## **RESPONSE TO COMMENTS**

## **CHAPTER 4 RETAIL PLAN**

The Applicant received comments requesting additional information on the shadow impacts to the Kendall Square Rooftop Garden. The Master Plan Shadow studies in Chapter 7, *Environmental Impacts* have been expanded with the supplemental presentation and animation file (2018-1102-IDCP-RTC-SHADOW STUDIES.ppsx) which illustrates shadows for the district for the following full days: Equinox: March 21 & September 21 (EST), Summer Solstice: June 21 (EST), Fall: October 21 (EST) and Winter Solstice: December 21 (EST). R7.1 FIG. 7.13-7.16 summarize the new shadows and the existing shadows with an enlarged area of the Kendall Square Rooftop Garden. The shadow studies are representative of the revised massing for Commercial Building B illustrated in this Response to Comments Chapter 1 (IDCP Oct Massing). Overall, for the specific times represented in R7.1 FIG. 7.13-7.16, the change in shadow on the Kendall Square Rooftop Garden due to the revised IDCP Oct massing is negligible. The East facade reduction allows more light to enter the Kendall Square Rooftop Garden at the new vertical connector location at certain times of the year and

R7.1 FIG. 7.17

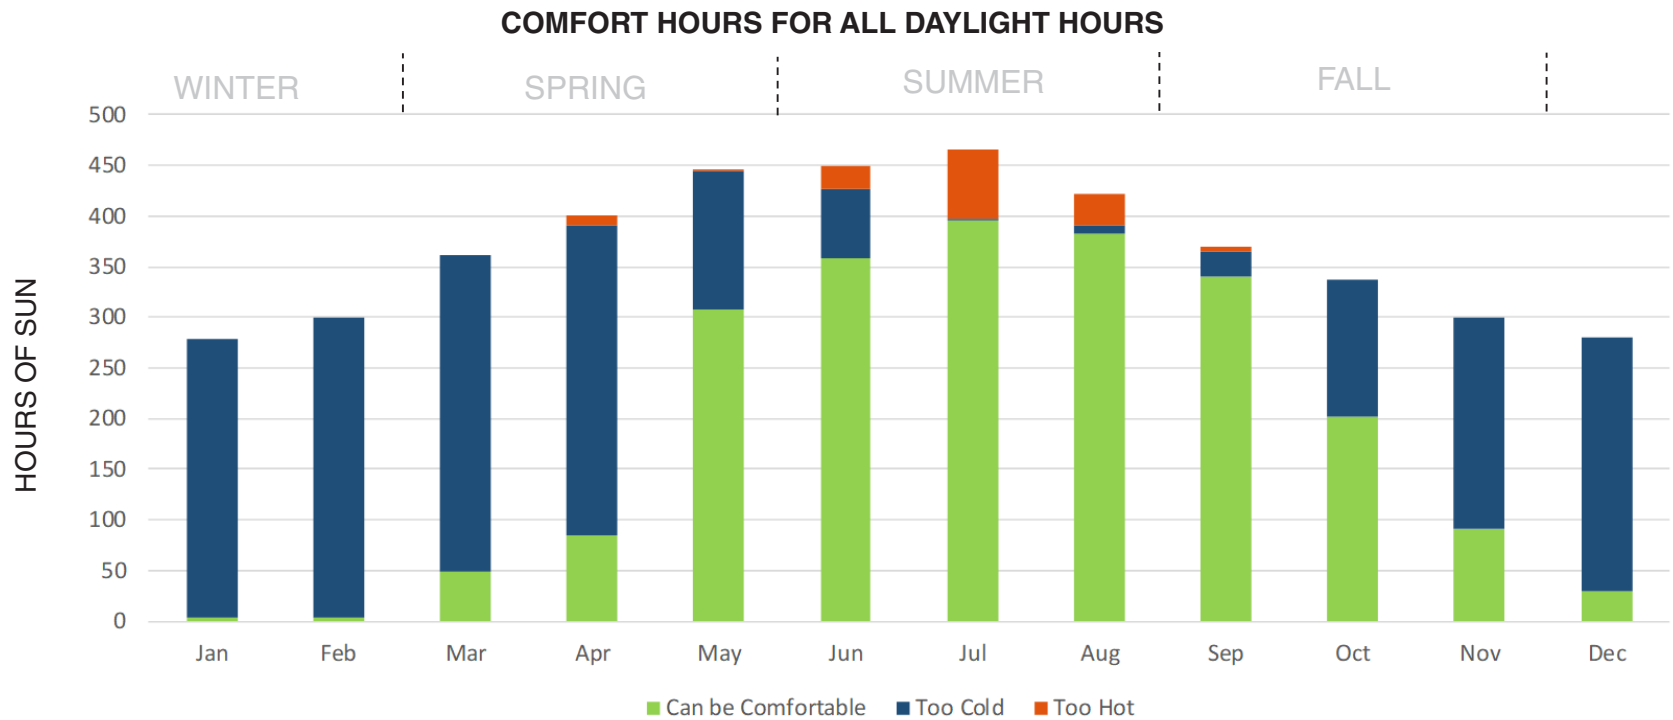
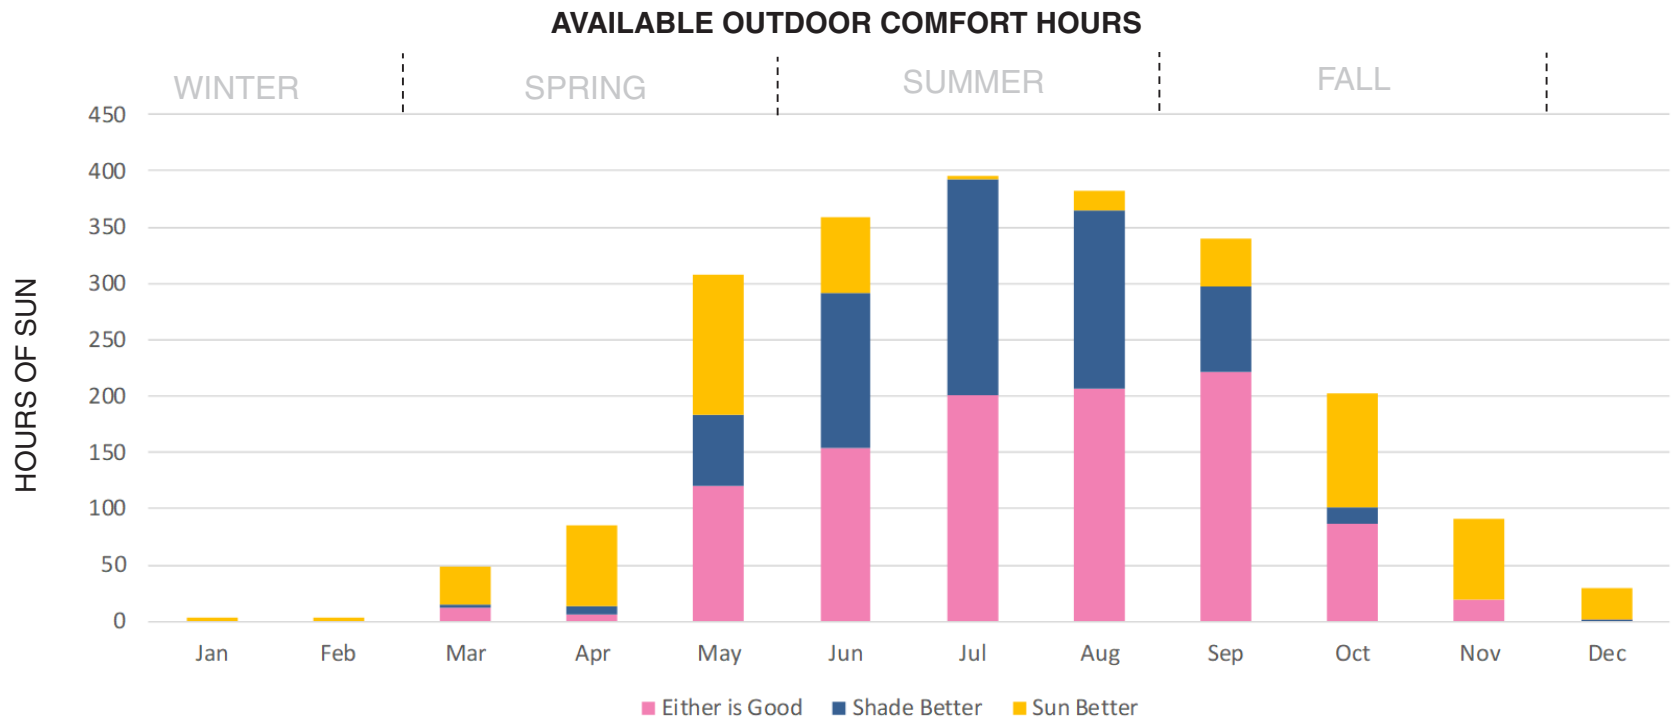
In addition to the Shadow Studies: to provide a more complete picture as it relates to human comfort, the Applicant conducted a Thermal Comfort Study using Energy Plus Weather data (EPW) for Boston and the Universal Thermal Climate Index Method (UTCI). A Thermal Comfort Study is a tool used to help analyze the composite impacts of sun, shadow, humidity and other external climate factors that determine the perception of comfort at a specific time. For example, the combination of bright sun and high humidity are generally uncomfortable as are high shade and low temperatures. The study shows the impact to the range of comfort levels on the Kendall Square Rooftop Garden based on the proposed building massing. The study also provides better informed determinations on impact to planting and programmatic uses on the Kendall Square Rooftop Garden as described in response Chapter R3.1

Figures R7.1 FIG.7.17-7.23 show the comparison of the existing conditions and proposed conditions created by Commercial Building B (Oct 10 Massing). As shown in the following analysis, during the warm summer months, human comfort can be increased through the addition of shade “Tactical Shade”. During the period of greatest use (June-September), human comfort on the Kendall Square Rooftop Garden will increase. See R7.1 FIG. 7.22 On an annual basis, there are approximately 20 additional hours of comfort representing a 4 percent increase.

R7.1 FIG. 7.22

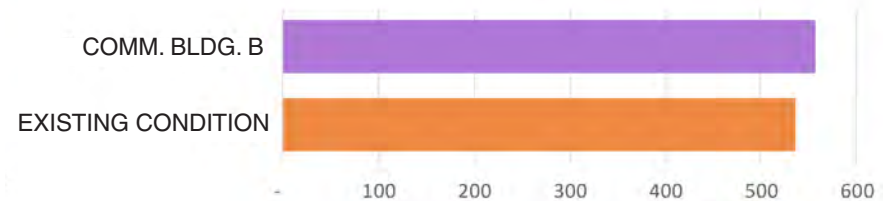
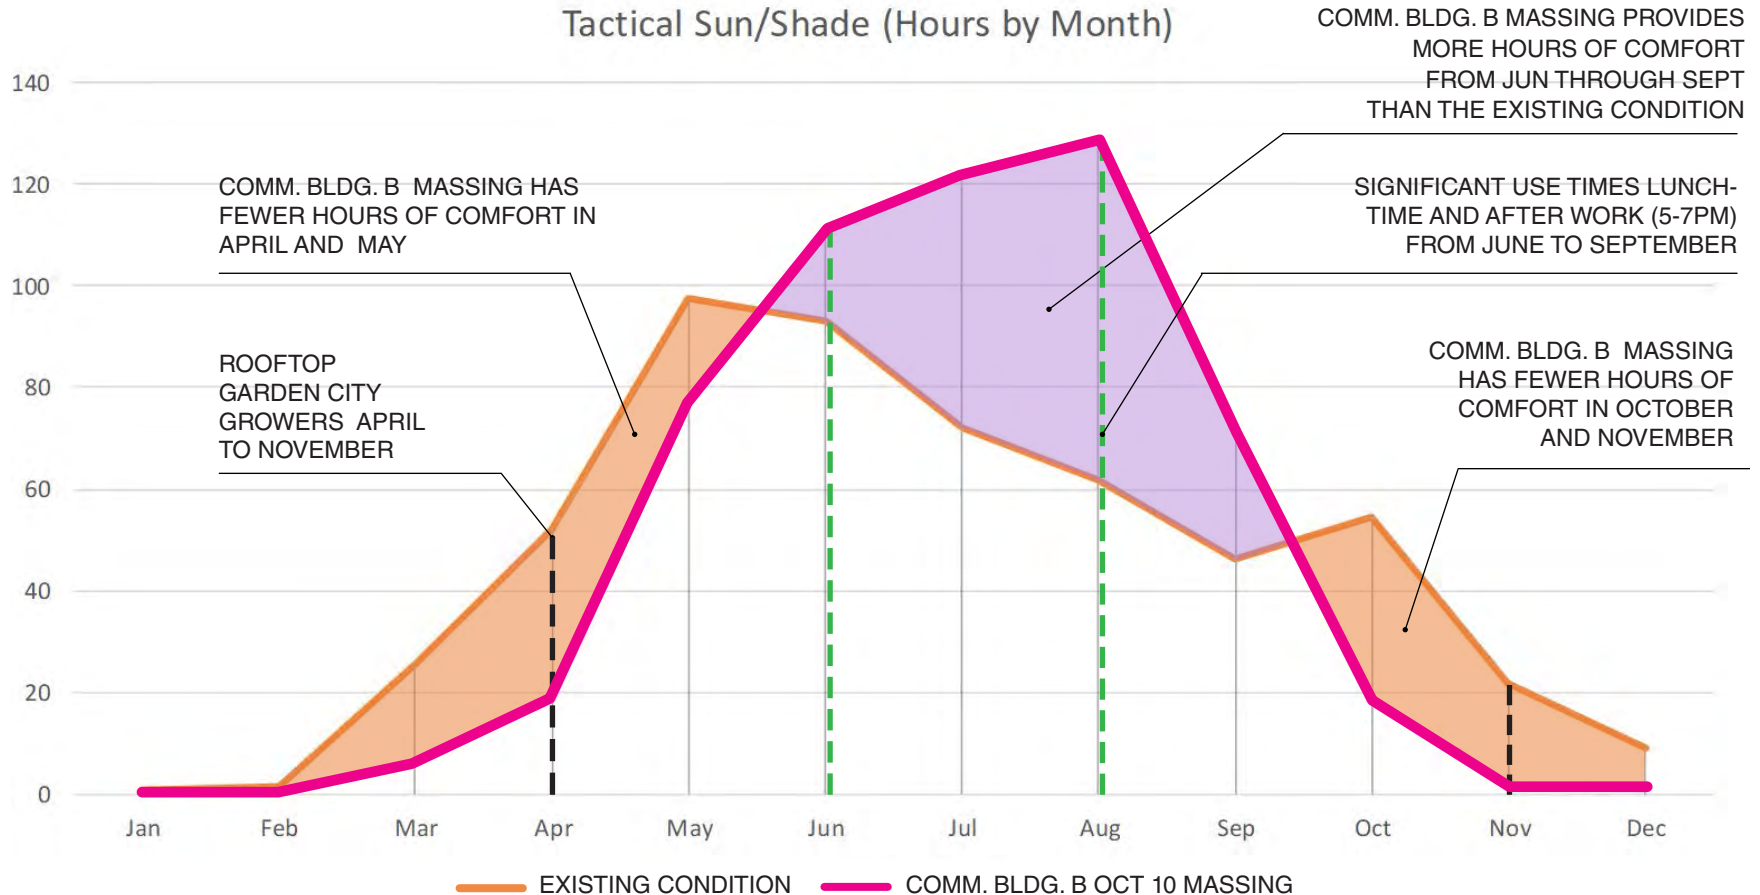
**APPROX 20 HOURS  
(4% INCREASE IN COMFORT HOURS)**

*Image 2: Rendering Showing 325 Main Street Massing Tested for Wind Study (Left) and the Updated 325 Main Street Massing (Right) – Views from North*

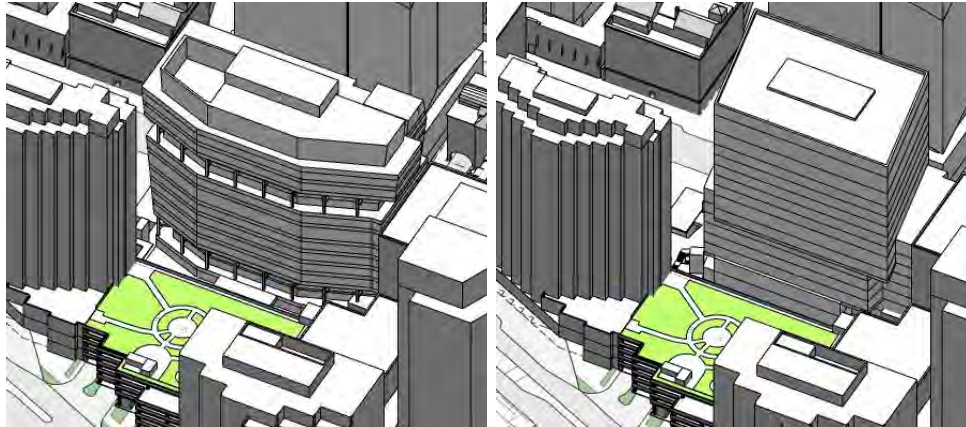
The Applicant received comments expressing concern over proposed wind conditions north of Broadway, in the Kendall Plaza and the Kendall Square Rooftop Garden. The Master Plan wind tunnel study presented in Chapter 7, *Environmental Impacts* of the Concept Plan Amendment, should be considered a baseline with the understanding that each individual building's Design Review submission will include an update to the baseline for comparative purposes. Accordingly, undesirable wind conditions that are presented in the Concept Plan Amendment are not proposed as final but are shown as a starting point with which to better inform the designs of each building and their associated public realm improvements.

As evident in **Images 1 and 2**, the updated massing sits on a similar size footprint as the massing tested for the wind study. Although the updated massing is a story taller, it is also narrower and provides additional massing setbacks which tend to intercept wind flows at higher elevations and may prevent those wind flows from reaching grade level, which is a positive feature from a pedestrian comfort perspective.

It is RWDI's opinion that the updated 325 Main Street massing is likely to result in similar wind conditions around the project site with some relatively localized variations to the predicted wind conditions presented in our report dated August 7, 2018. If the design team wishes to quantify these changes precisely, additional wind tunnel testing can be undertaken.
